**1 – ENGINE*****Timing gear drive belts on 505 vehicles with ZEJ-ZDK-ZDJL engines***

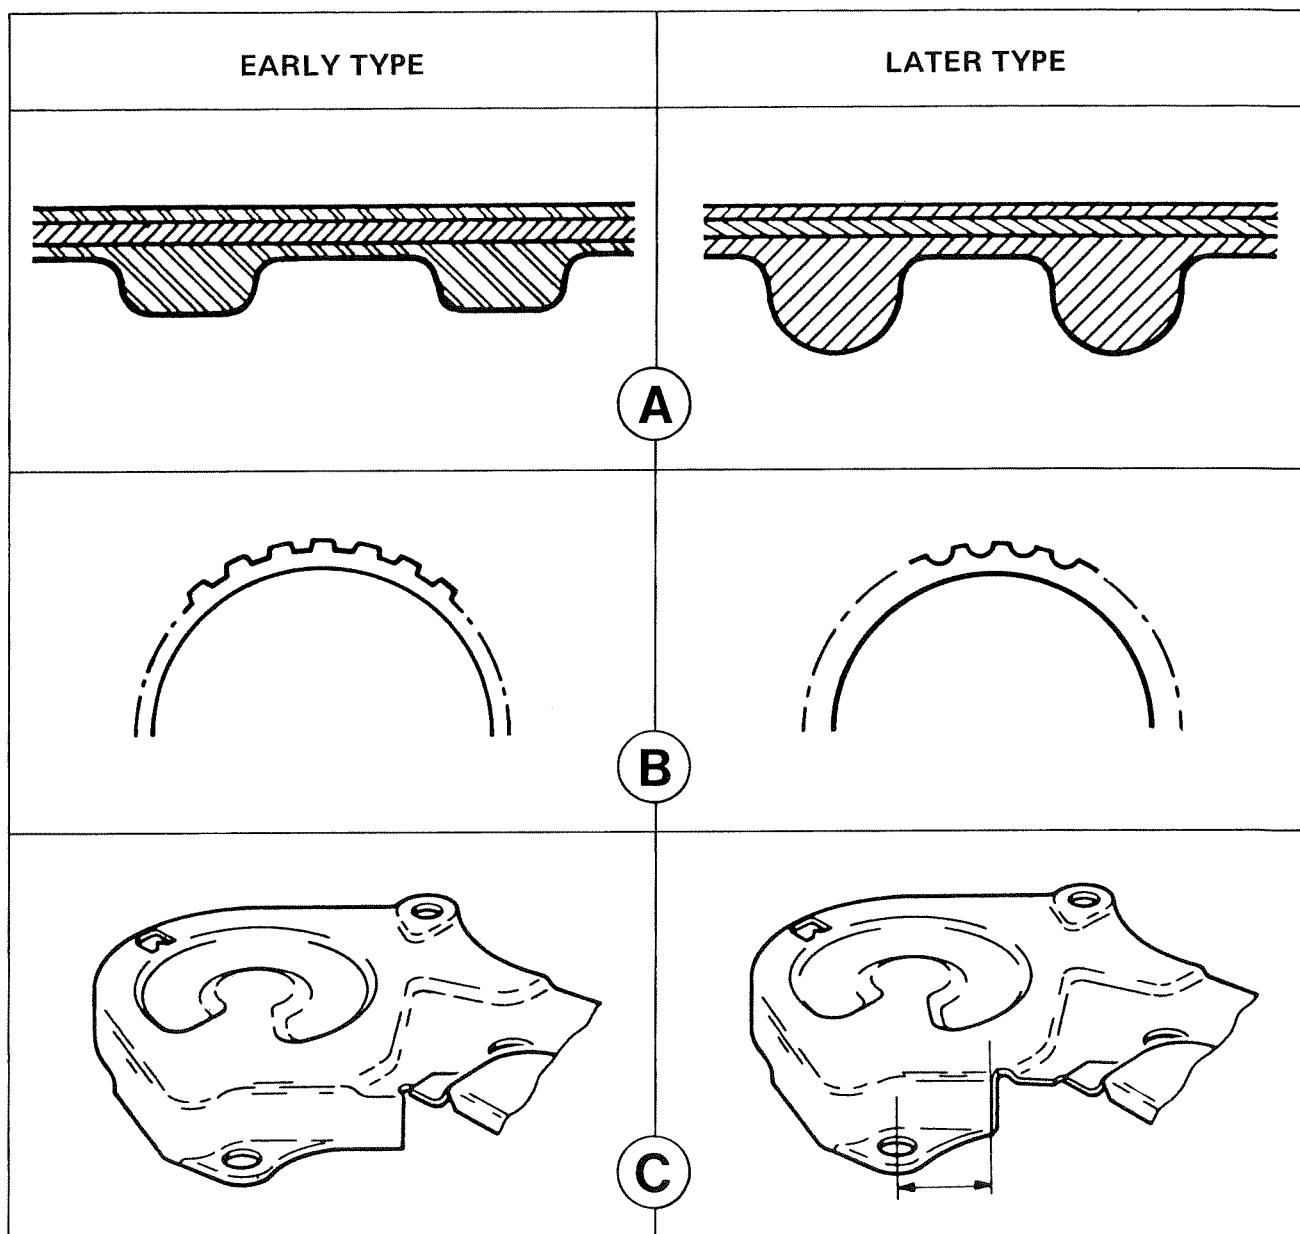
505 vehicles with ZEJ, ZDK and ZDJL engines will be fitted with a new toothed timing gear drive belt.

This belt has a specific tooth form and has involved fitting new type sprockets to the crankshaft, intermediate shaft and camshaft. Its specific shape and the difference in its thickness have also made necessary an additional cut-out in the timing housing.

The modification only concerns the shape of the belt teeth. The principles of setting the timing and adjusting the belt tension remain the same.

The component parts of these two assemblies are not individually interchangeable. The later arrangement can only replace the early arrangement as a complete assembly, that is to say the three sprockets, the toothed belt and the timing housing must all be replaced.
